Discussion.

The Author introduced the Paper with the aid of a series of lantern-slides.

Fig. 13.

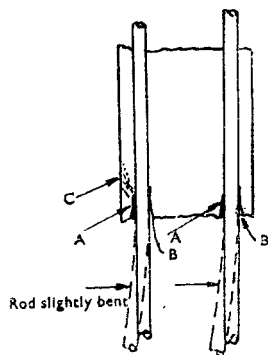
Fig. 13 showed a section of a pile. It appeared to be rather drastic treatment to beat off the initial rust with a heavy sledge-hammer, especially

because there was always a tendency for the bar to bend slightly and to crush the concrete on side (A) rather badly and to leave a gap on side (B); moreover, the use of a heavy sledge-hammer might cause minute cracks at (C), which would never be filled by gunite. Similar remarks applied to beating off damaged concrete with a sledge-hammer. That treatment was too drastic, because it might bruise the surface of the concrete into cracks so fine that the concrete did not come away, but through which moisture would percolate in years to come and corrosion continue.

He considered that the danger in using the heavy hammer was not so great as the risk of not getting off all the defective material, and, despite the warnings which had been uttered, he would continue to use a heavy hammer.

Figs. 17.

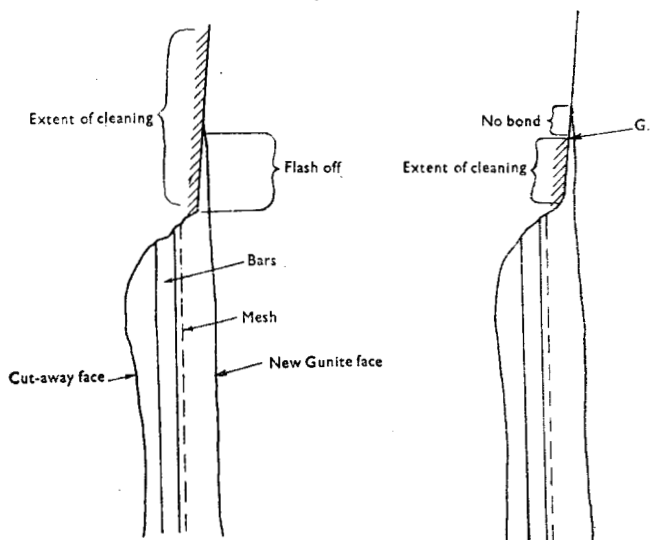
Mr. S. C. Carter observed that it was not clear whether the Author invariably removed all the concrete from behind the reinforcement or if he sometimes gunited with, say, half the rod exposed. It appeared to be rather risky to apply a covering over only half the bar, because the adherence of the gunite material would not be so good. Had the Author ever confined the guniting to part of the surface of the rod and not placed it right round.

Mr. Carter had shown a construction at the edges such as that illustrated in *Fig. 13*, but, so far as the work at Southampton was concerned, there was so much to do that he could not slow it down for any such detail as that. For cutting away, however, he would in most cases proceed as shown in *Fig. 17*. The gun-spray was not a pencil-point spray but a rather broad spray, and one could not finish off as at F in *Fig. 14*. The gunite would overlap and there would be a flash-off possibly 6 inches in width. He wished to emphasize that the surface on which the flash-off came should be clean. If it were left in the condition brought about by the sea and oil, a good bond would not be obtained and cracking away would start at G (*Figs. 17*). The crack might not do any harm at the time, but future failures might commence to build up there. Mr. Carter had asked

if the Author invariably exposed the whole bar before applying gunite. In the case of columns or struts the old material was cut away as shown in *Fig. 18*. That was usually done in two operations, guniting the first half before cutting the second. An exception to that practice occurred in the case of the Kahn reinforcement, which was in most cases only partially exposed. Such differences in method bore largely on the final remarks in Mr. Jackson's contribution in regard to the engineer's views on the methods to be adopted.

Fig. 18.

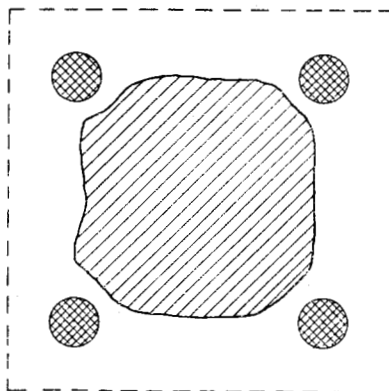
With regard to the shooting strips, he considered that the right course to adopt was to put light shooting strips at the corners of the beam. For instance, it was possible to put two light shooting strips at each corner, fixed on to the existing bars; to shoot in between them and obtain the thickness without any fear of rebound; and then to remove the strips and complete the operation round the sides and the corners. Especially in the case of a pile, shooting strips were useful from the point of view of cover. The cover could not be tested by taking the depth of the original surface, because at that particular portion of the pile the deteriorated concrete had been cut away and, wherever the trial was taken, the depth behind the original structure was unknown. Therefore, it was much better to bring the whole thing out to the dimensions that one knew were covering the corners. Without shooting strips the only satisfactory method was to stop work and cut the gunite out while it was still unset and re-shoot it. The shooting strips did not affect the question of rebound, and they gave a very pleasing effect; the structure might look even better than in its original form.

Mr. Jackson's description of the shooting strips was a useful addition to the technique. The value of 10,000 lb. per square inch given in Mr. Pearson's Paper referred to cubes cut from slabs built up with the cement gun.
